Delegated Report

Prior Approval Extensions Application

Application no:	20221086
Location	23 Pine Avenue Gravesend Kent DA12 1QY
Proposal:	Single storey rear extension with a depth of 6.00 metres, maximum height of 3.00 metres and eaves height of 3.00 metres.
Applicant:	Mr K Singh
Site Visit	Desktop Assessment

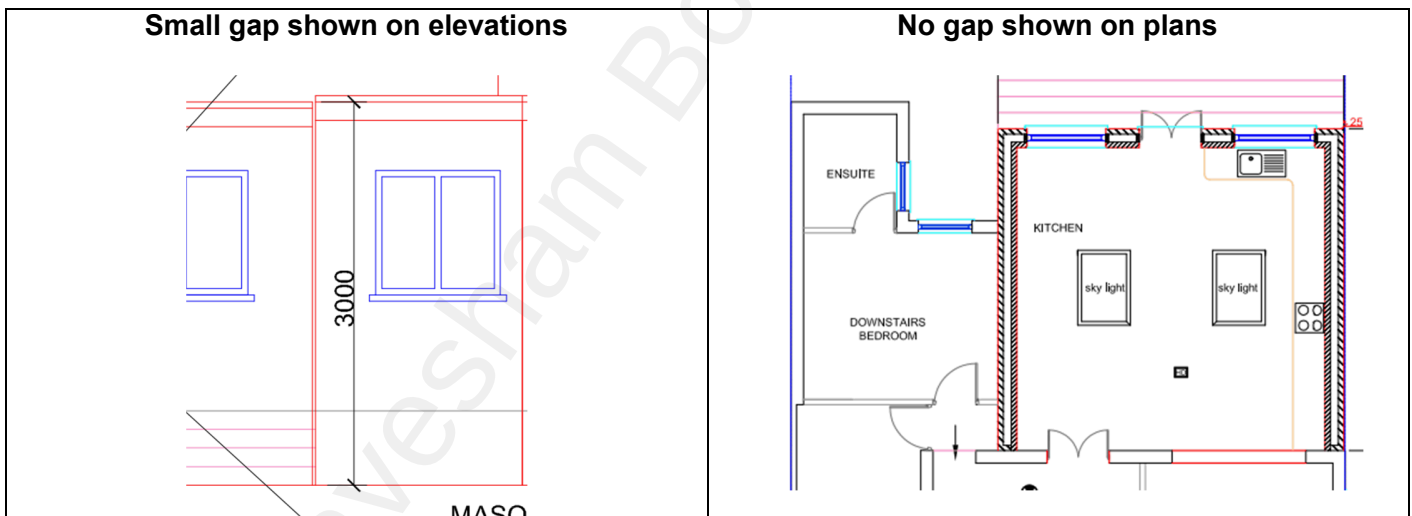
The plans submitted are inconsistent as the elevations show a small gap between the proposed development and the existing extension, yet the floor plans show the extensions will be connected:

The proposal fails to comply, with Class A, Part 1 Schedule 2 and Article 3 of the Town and Country Planning (General Permitted Development) (England) Order 2015 (as amended), regardless of the above, however, for the purposes of the report, the application has been assessed with the view that the extensions are connected.

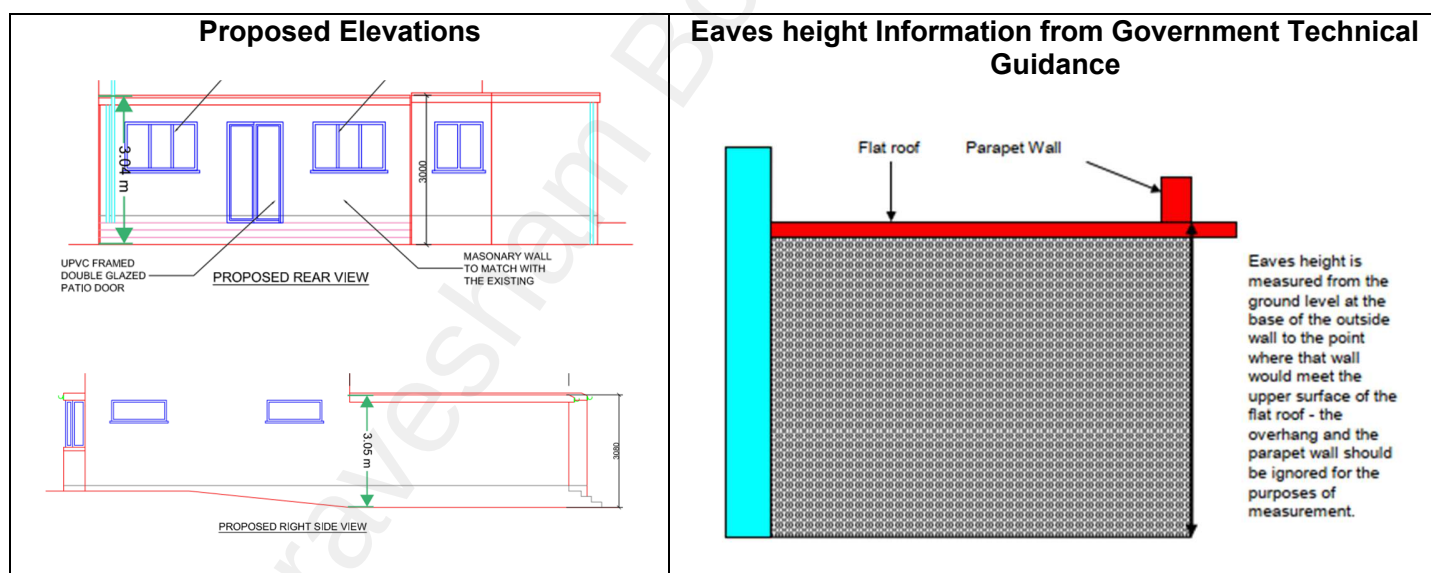
The proposed plans show the proposal would fail to comply with A.1 (i), as the development would be within 2.00m of the boundary, and the eaves of the enlargement would exceed 3.00m (indicated by below measurements).

In addition, the proposed extension would join an existing side extension which means an assessment under (ja) is required. Class A.1 (ja) states that “any total enlargement (being the enlarged part together with any existing enlargement of the original dwellinghouse to which it will be joined) exceeds or would exceed the limits set out in sub-paragraphs (e) to (j)”.

Therefore, the development fails under Class A.1 (i), as the eaves of the total enlargement are within 2.00m of the boundary and exceeds 3.00m (shown above). Furthermore, the proposed development fails under (j)(iii) as the total enlargement would extend beyond a wall forming a side elevation of the original dwellinghouse and
